## Change Order Request

**Project:** 1923025-02  
La Crosse Center Expansion & Renovation  
400 La Crosse Street  
La Crosse, WI 54601

**COR #** 194.00

Proposal Request Number: 026  
REVISED-2

**3M2-10A**

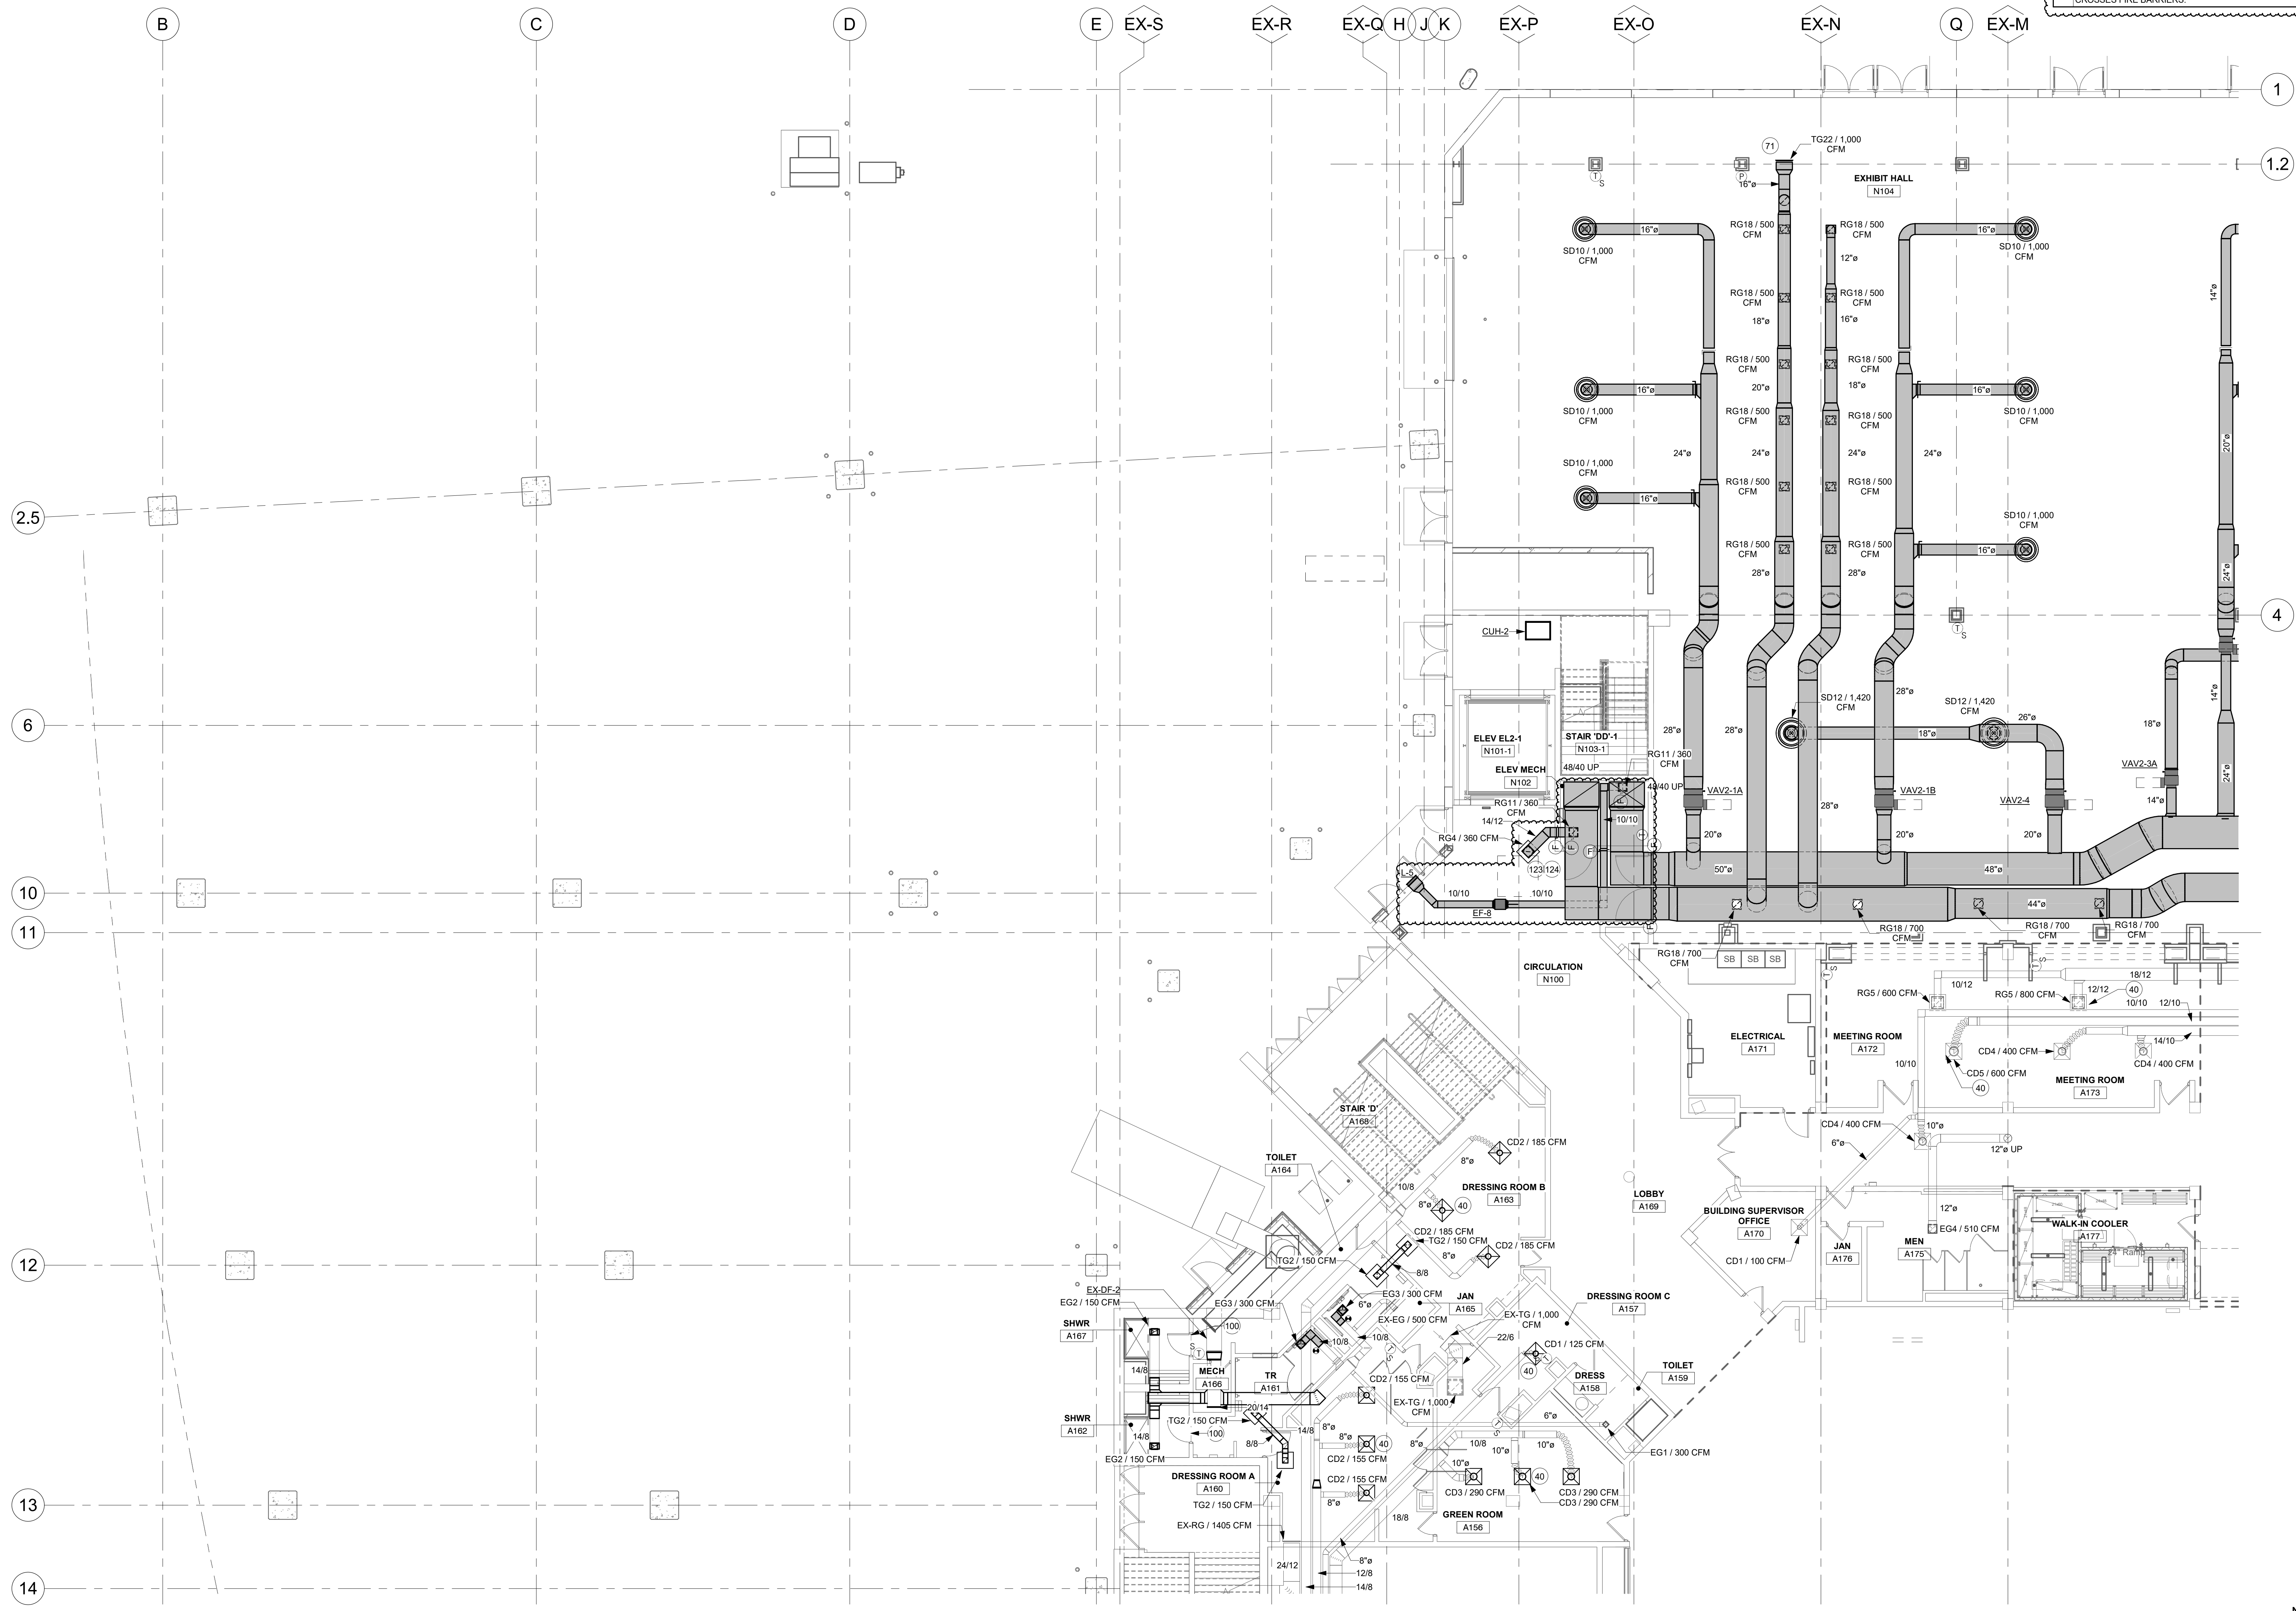
a. New exhaust fan (Ef-8) and louver (L-5) added to exhaust elevator equipment room.  
b. Ductwork routed through wall to ceiling grille for exhaust and transfer air with required fire dampers.

c. New keynotes added corresponding to changes on plan.
- Item 4: Refer to Revised Plan Sheet 3M5-11 – HVAC Schedules and Specifications  
a. New exhaust fan (EF-8) added to schedule.

SHEET: 3M5-12

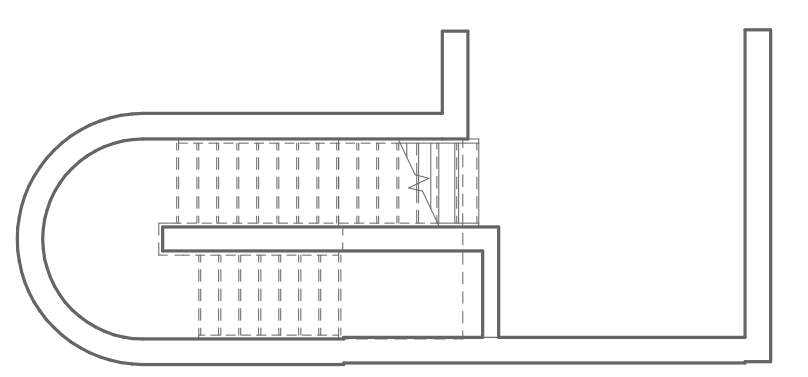
- Item 5: Refer to Revised Plan Sheet 3M5-12 – HVAC Schedules and Specifications  
a. New Louver (L-5) added to schedule.
- Item 6: Refer to Revised Plan Sheet 3E2-11A

SHEET 3E2-11A

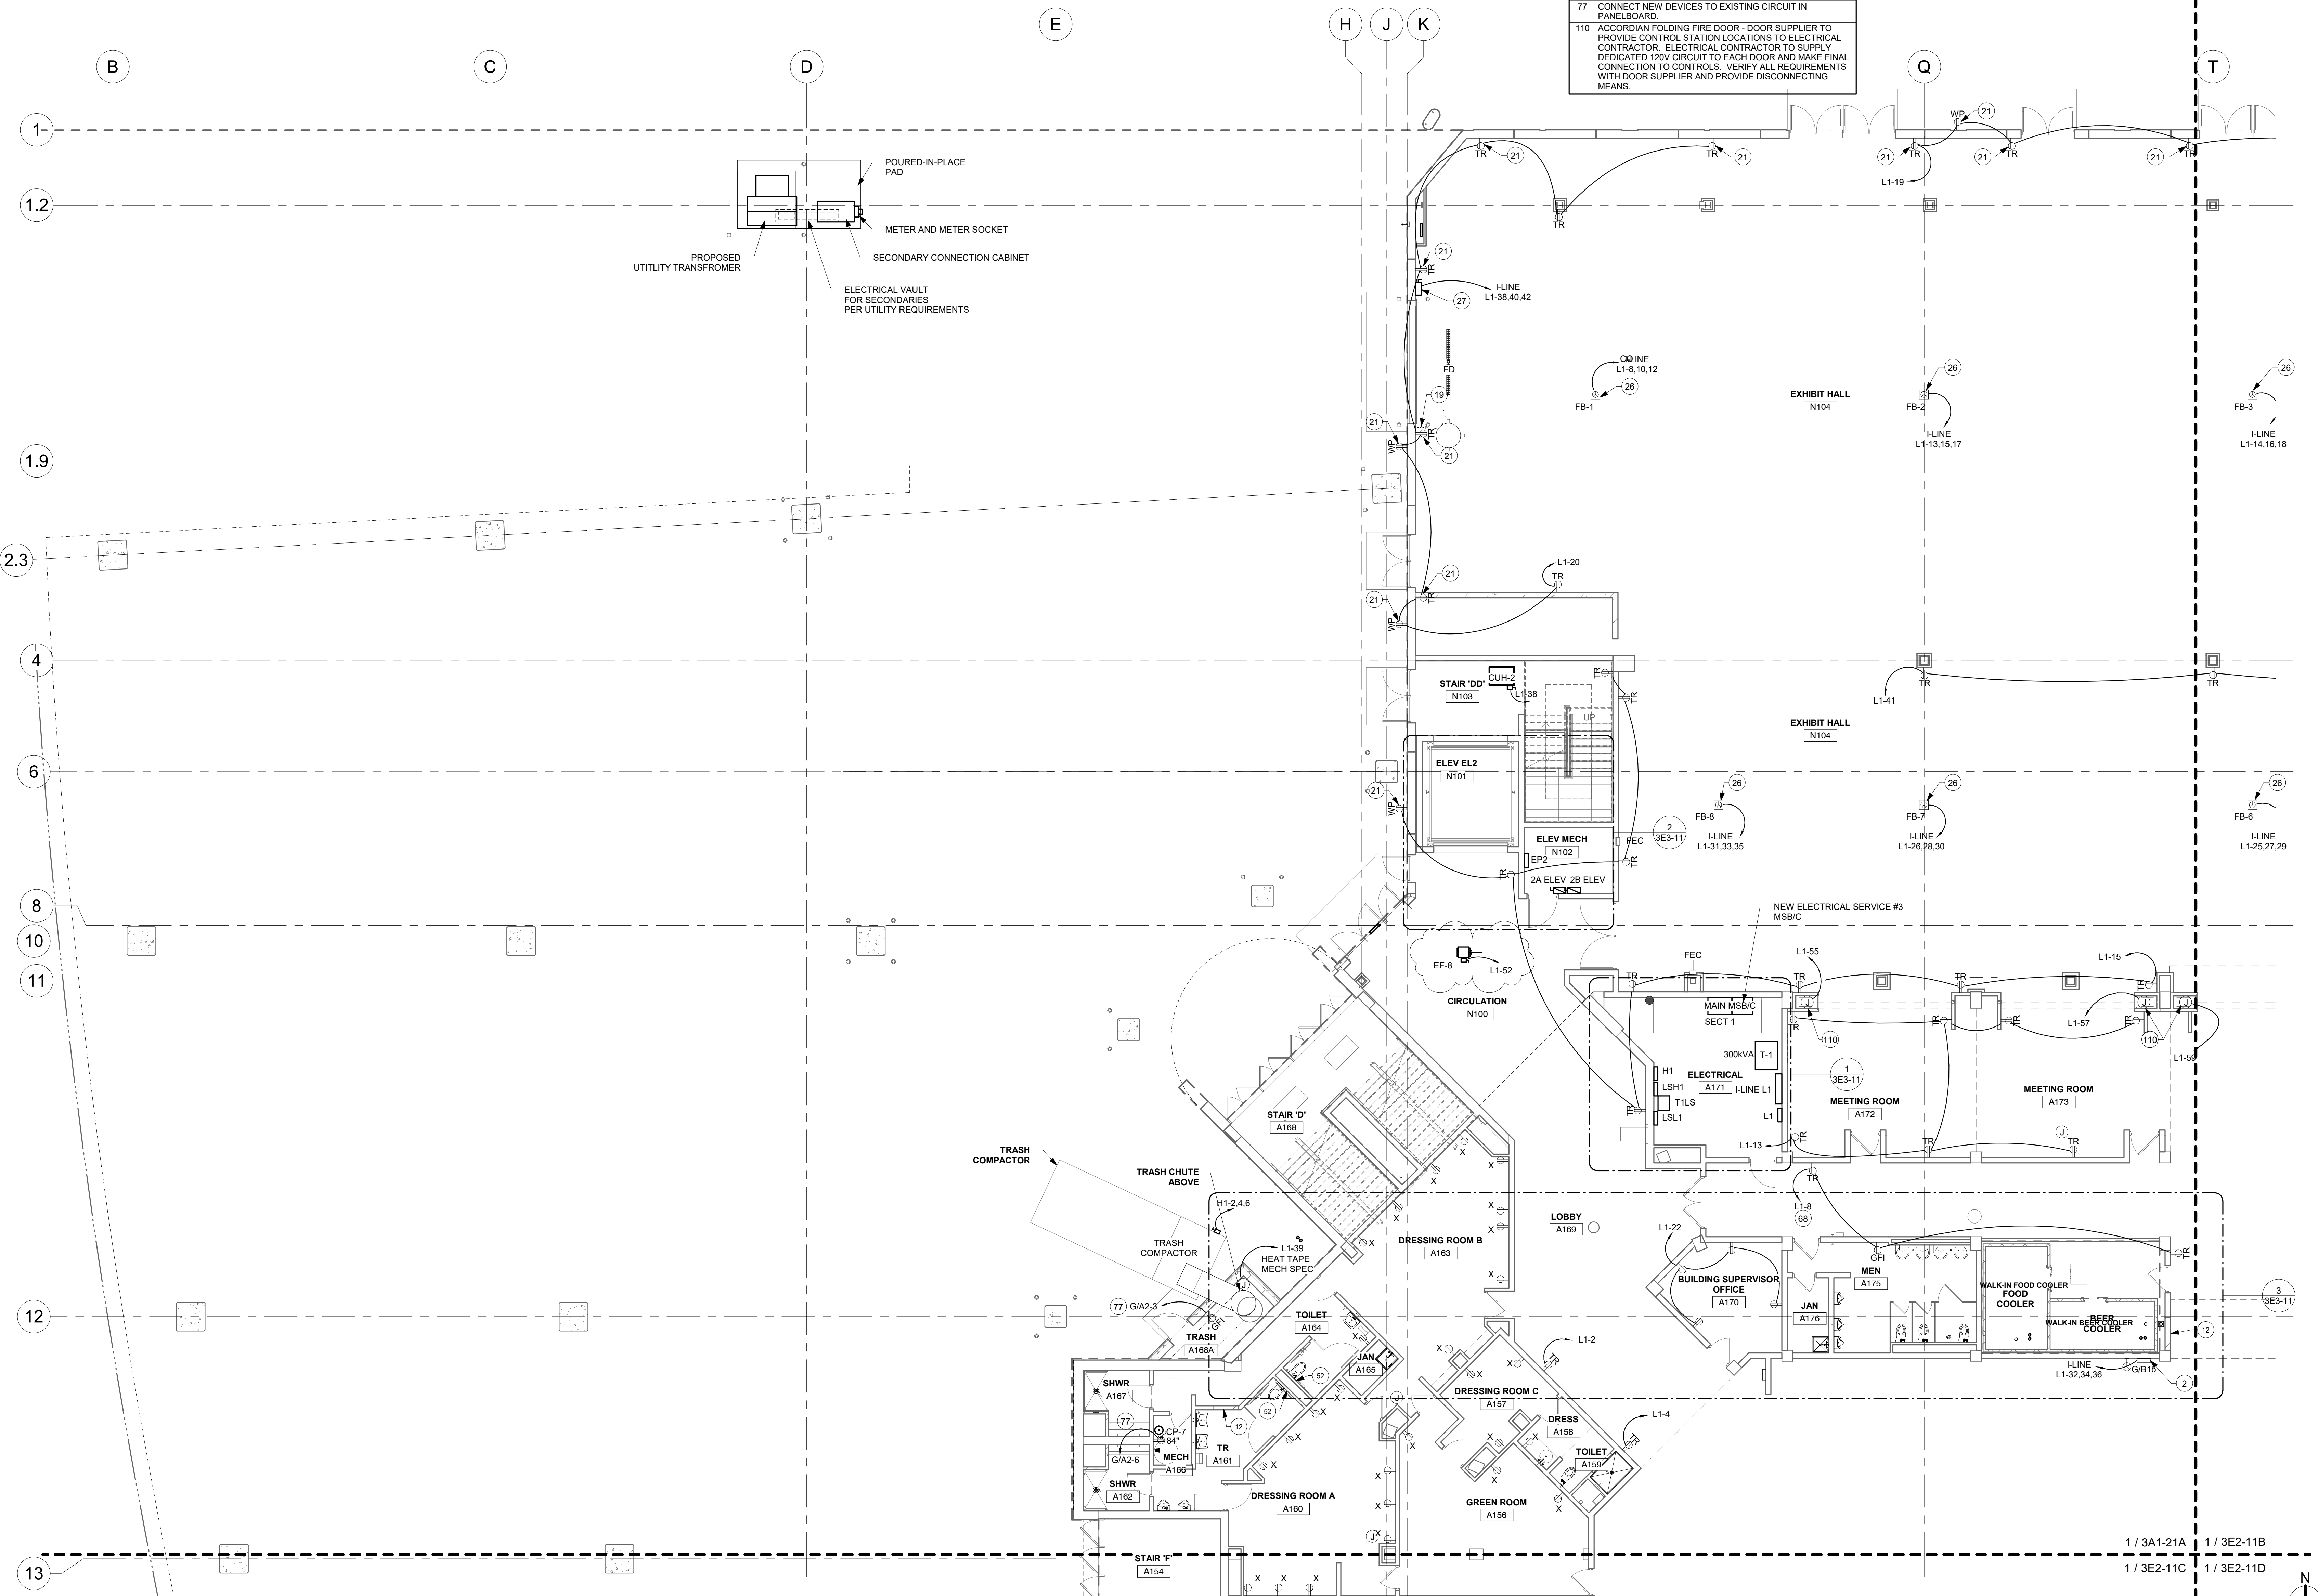
a. Added power to exhaust fan as indicated on drawing
